## CORPORATION OF THE CITY OF NEW WESTMINSTER

**ADDENDUM #1  
NWIT-10-21A  
Heat Pumps Addition  
Engineering Operations Main Building, New Westminster, BC**

PART MAIN FLOOR PLAN. - HEAT PUMPS ADDITION  
 N.T.S.  
 ENGINEERING OPERATIONS MAIN BLDG. SKA-1

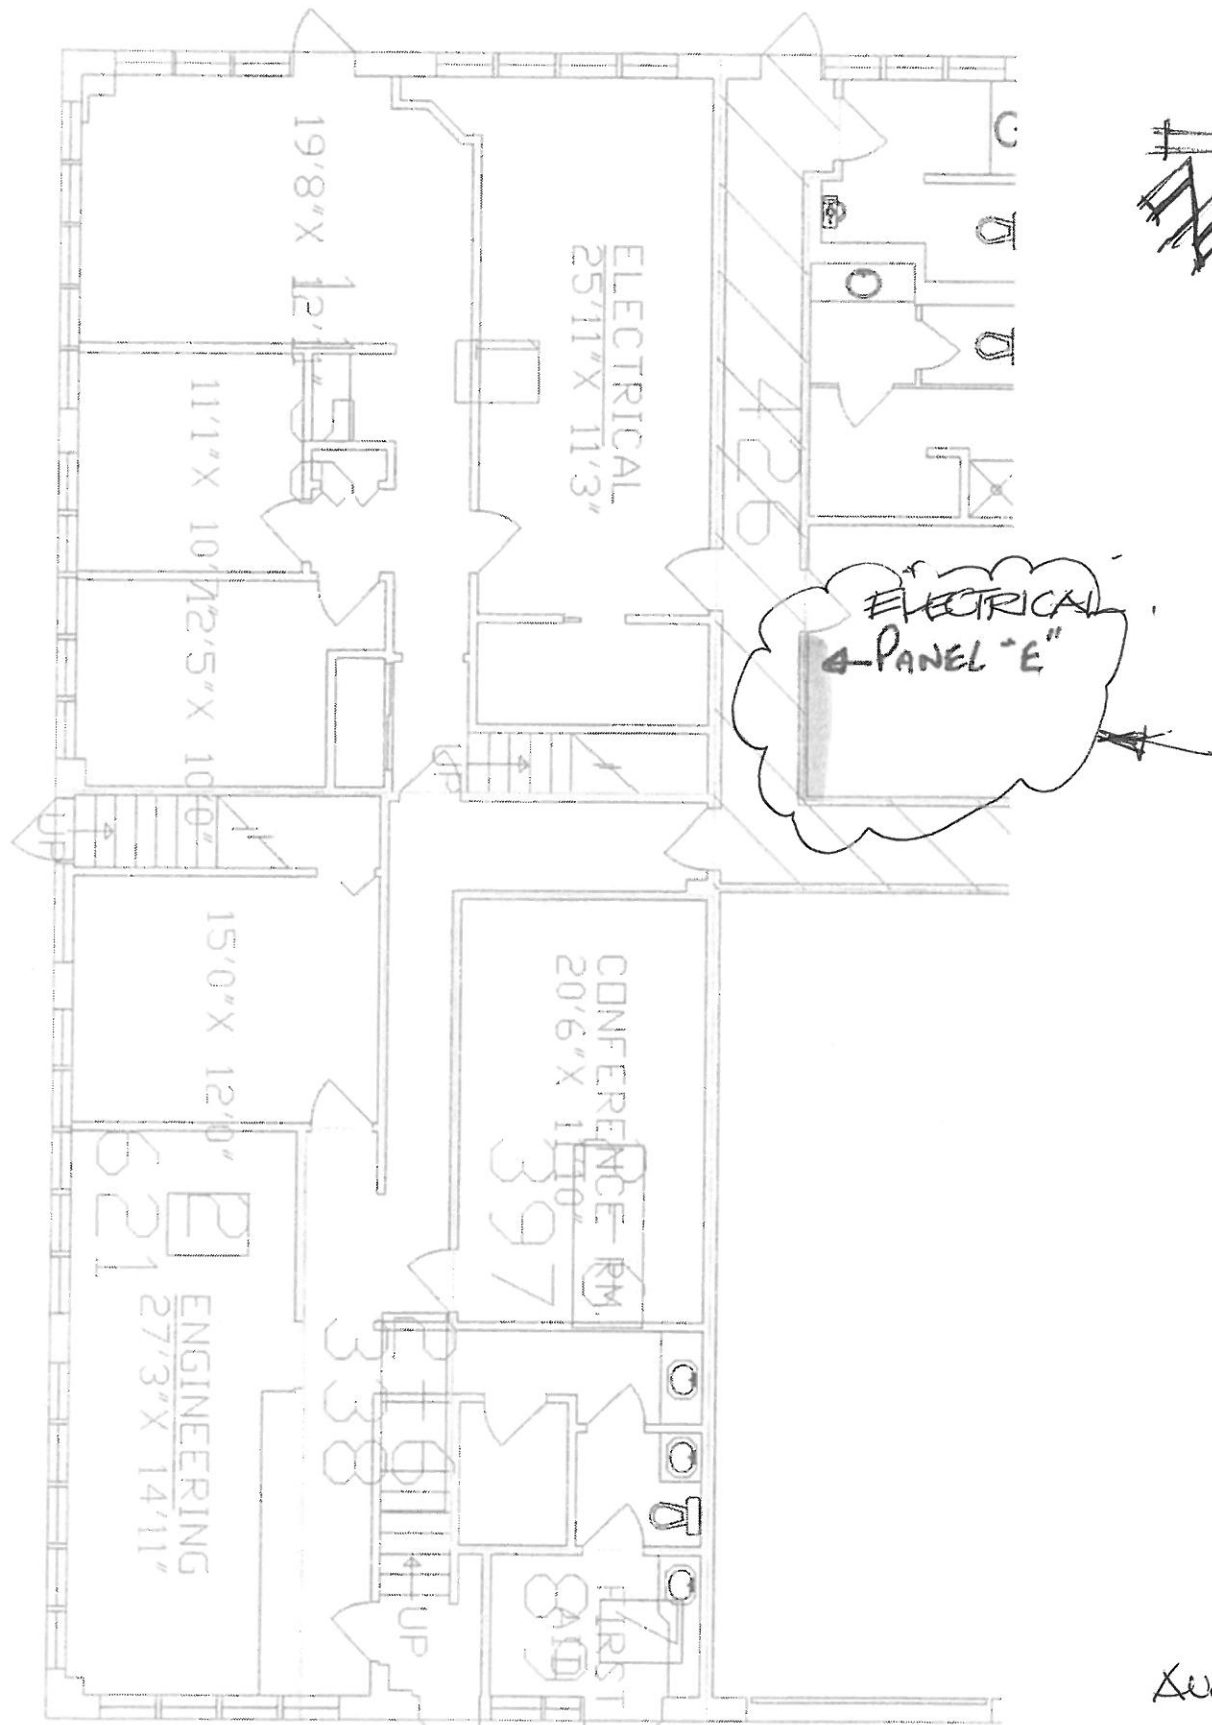
- 1 Add the location of the existing electrical panel as per sketch SKA-1 dated August 18, 2010 (1 page attached) <ADD> Sketch SKA-1. The City has confirmed that the panel has the capacity to provide the required power to the mechanical equipment specified.
